**Project Name** | BCWD Permit 23-17 Sundance Townhomes**Date** | 12/11/2023**To / Contact info** | BCWD Board of Managers**Cc / Contact info** | Ryan Sailer, Timberland Partners ; Dan Sjoblom, PE / Alliant Engineering**Cc / Contact info** | Karen Kill, Administrator / BCWD**From / Contact info** | Camilla Correll, PE / EOR; John Sarafolean, EOR; Paul Nation, PE / EOR**Regarding** | Permit Application No. 23-17 Engineer's Report

**Recommendation: Approve with Conditions**

Figure 2: Existing site drainage

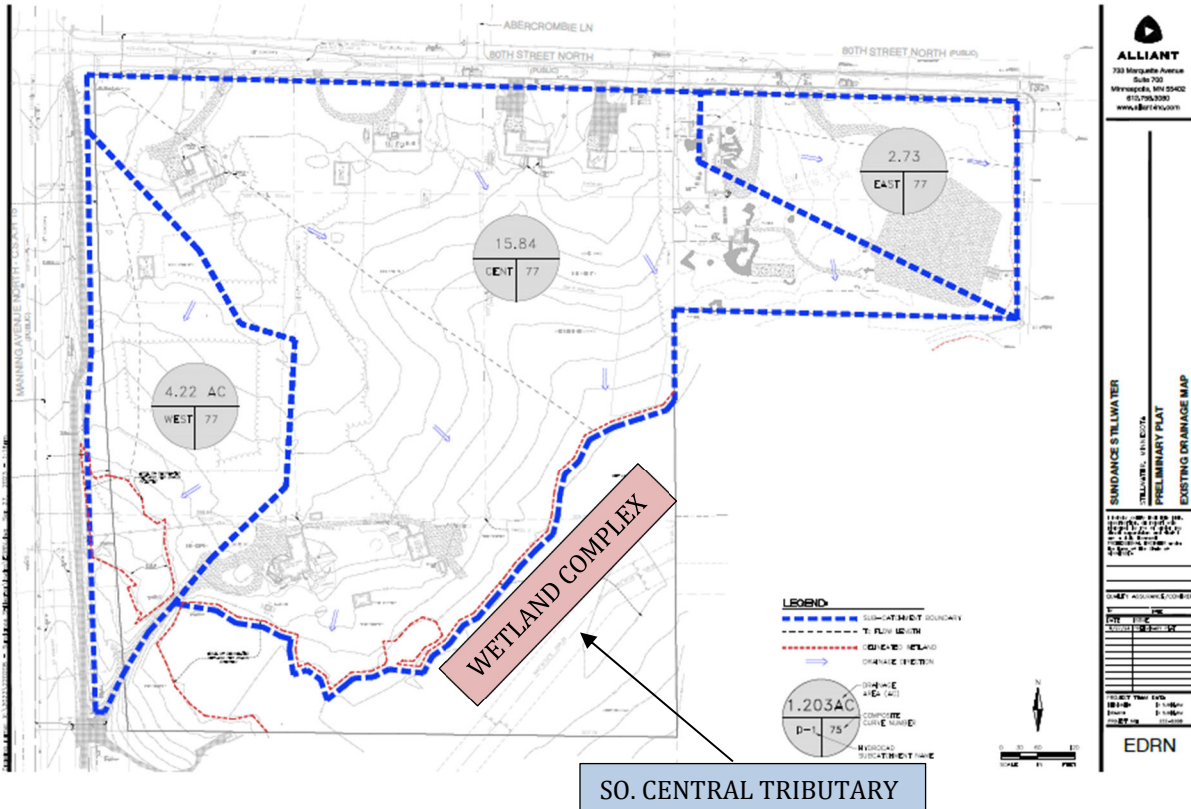
*Existing drainage from the site consists of three drainage areas: west, central, and east (Figure 2). The drainage areas are 4.22 acres, 15.84 acres, and 2.73 acres respectively. Under existing conditions, the stormwater runoff from the site sheet flows to the wetland complex located along the southern portion of the site. Under proposed conditions, these drainage areas are combined into two drainage areas: north and south, the drainage areas are 10.63 acres and 12.16 acres respectively (Figure 3). Stormwater runoff is discharged from the site to the wetland complex via storm sewer from the two wet ponds.*
